Access Compliance Report

Public Rights-of-Way

(Curb Ramps)

Intersection ID: 7165	Main Street: PINE_ST	Cross Street: WILMA_LEE_CT	Location:	E
ADA ID: 6F54EEA2ECFB	Ramp Type: BlendTrans2	Initial Pass/Fail: Fail	Overall Compliance: No	Severity Score: 10
Codes/Mitigation Info/Possible Solution		Field Measurements/Component Compliance

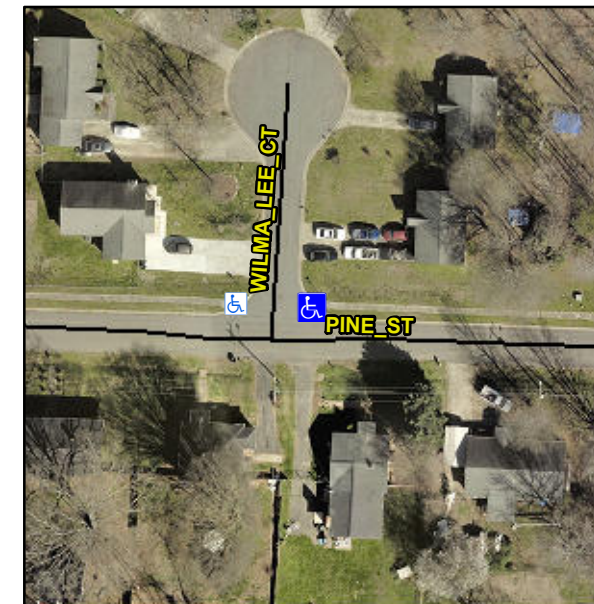
R304.5.1, R304.5.3

Compliance	Description	Data	Compliance	Description	Data
N/A	Ramp Length (in)	39.0	Yes	BlendTrans Slope (%)	2.1
No	Ramp Width (in)	47.5	No	BlendTrans XSlope (%)	3.0
N/A	Flare Type LT	N/A	N/A	Flare Type RT	N/A
N/A	Flare Slope LT (%)	N/A	N/A	Flare Slope RT (%)	N/A
N/A	Flare Traversable LT?	N/A	N/A	Flare Traversable RT?	N/A
N/A	Landing Length (in)	N/A	N/A	DWS Provided?	N/A
N/A	Landing Width (in)	N/A	N/A	DWS Contrast?	N/A
N/A	Landing Slope (%)	N/A	N/A	DWS Length (in)	N/A
N/A	Landing X Slope (%)	N/A	N/A	DWS Full Width?	N/A
N/A	Landing Curb? (Y/N)	N/A	N/A	DWS Offset (in)	N/A
N/A	Shared Landing?	N/A			
N/A	Gutter Ponding?	N/A	N/A	Gutter Slope (%)	N/A
N/A	Gutter Lip Ht (in)	N/A	N/A	Gutter X Slope (%)	N/A
N/A	Painted X Walk1?	No	N/A	Painted X Walk2?	N/A
	X Walk 1 Direction	To W		X Walk 2 Direction	N/A
	X Walk 1 Width (in)	N/A		X Walk 2 Width (in)	N/A
	X Walk 1 Slope (%)	4.0		X Walk 2 Slope (%)	N/A
	X Walk 1 X Slope (%)	4.6		X Walk 2 X Slope (%)	N/A

N/A	Ramp inside XWalk1?	N/A	N/A	Ramp inside XWalk2?	N/A
	Road Slope (%)	4.6		Clear Space?	N/A
	Road X Slope (%)	4.0	N/A	Clear Space to XWalk (in)	N/A
N/A	Any Obstructions?	N/A	N/A	Storm Grate/Utility Hazard?	N/A
	Obstruction Type			Storm Grate/Utility Type	
		N/A			N/A
			Yes	Surface Condition? (G/P)	Good
			N/A	Curb Slope (%)	1.5

Remove & Replace Curb Ramp With Two New Directional Ramps or Equivalent.
